# SAFETY RECALL NOTICE

# SERVICE BULLETIN

Number: 09-002

## EC Series Electrical System Mandatory Product Improvement

Fig 1

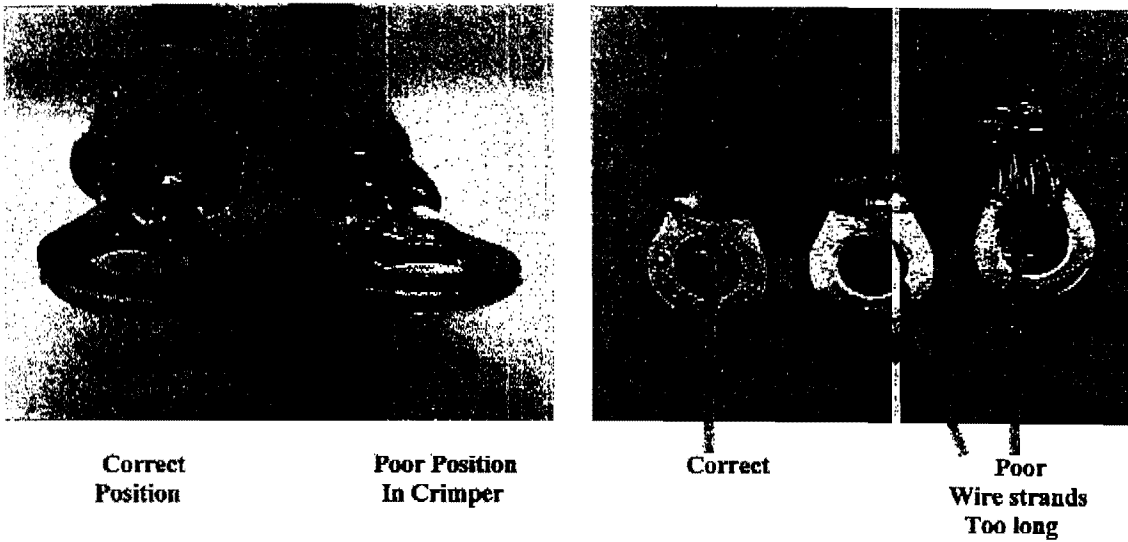
1. Crimps on the wires going to the terminal strip of the relay board should be uniform and tight. There should be no bare wire visible between the wire insulation and the terminal, and strands flush with terminal barrel. (Fig 1 & Fig 2)

Poor Crimp
